TRACT MAP NO. 73336

TENTATIVE MAP DATED <u>06/15/16</u> EXHIBIT MAP <u>06/15/16</u>

MAJOR SUBDIVISION **VESTING TENTATIVE** TRACT NO. 073336

IN THE UNINCORPORATED AREA OF THE COUNTY OF LOS ANGELES, STATE OF CALIFORNIA

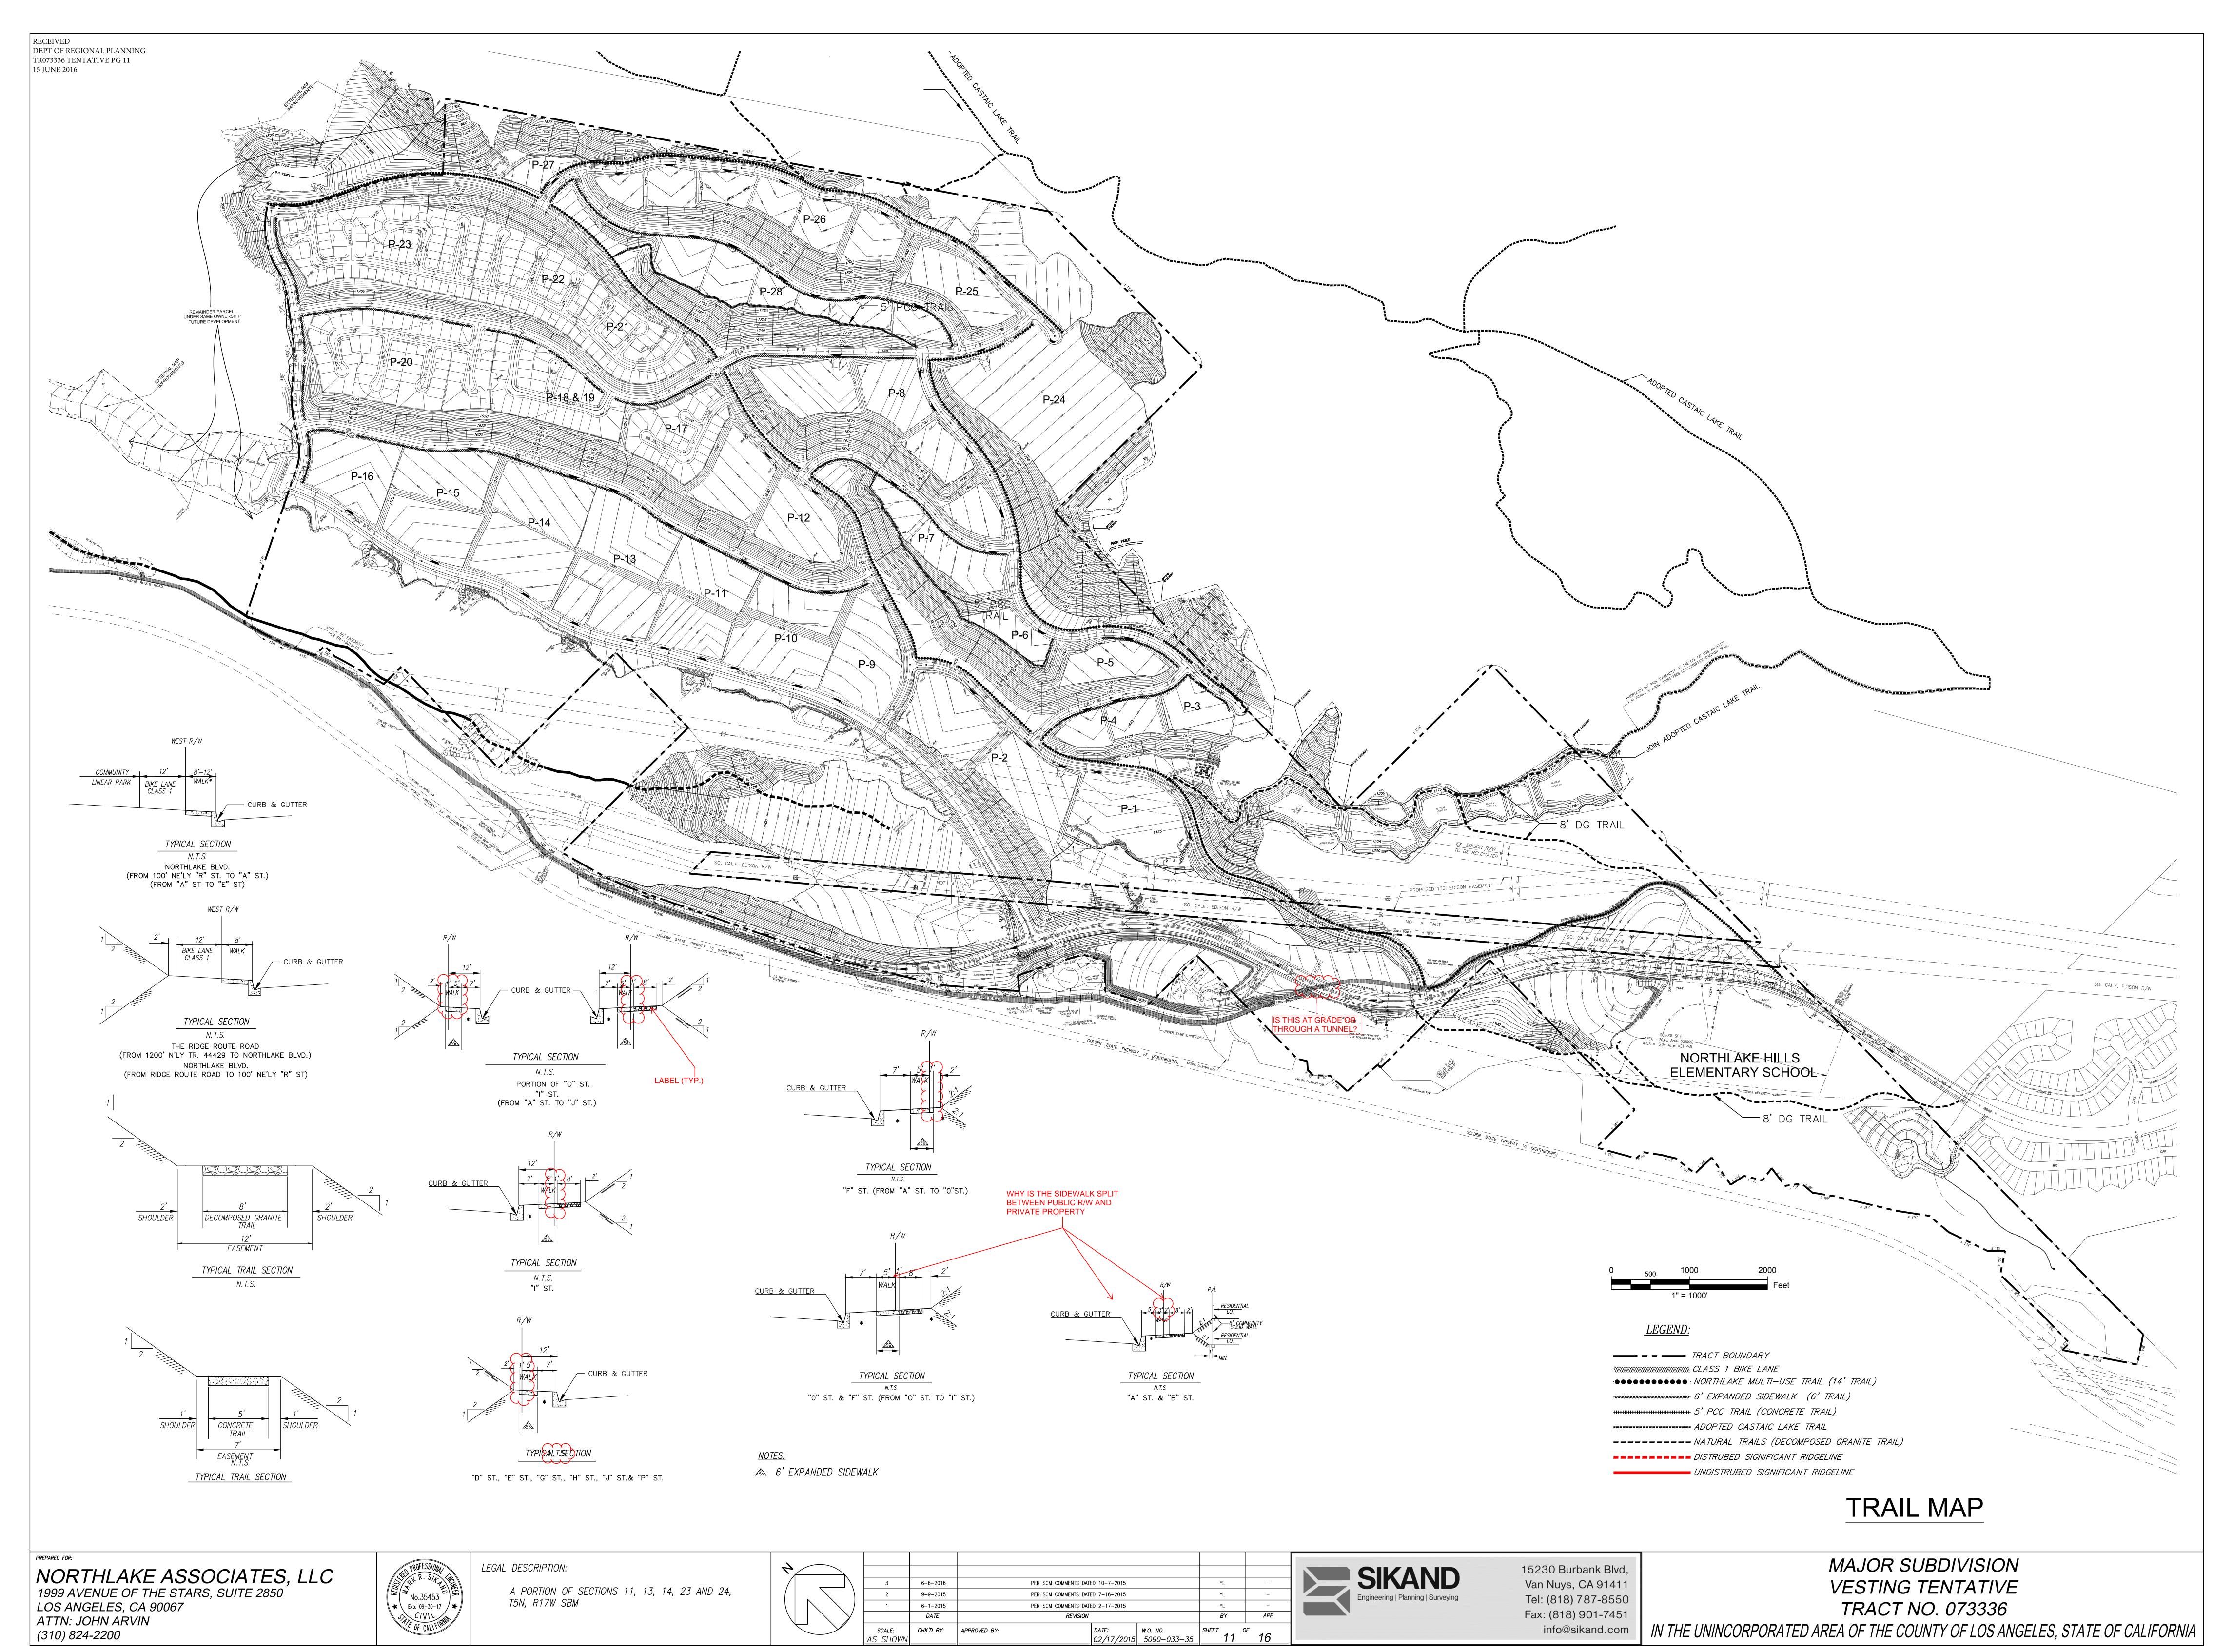
- 1. Traffic Study will be required. Please contact Andrew Ngumba of Traffic and Lighting Division, Traffic Study section at (626) 300 4851 for requirements.
- 2. A revised tentative map and exhibit map are required to show the following items:
  - a. See attached for comments.
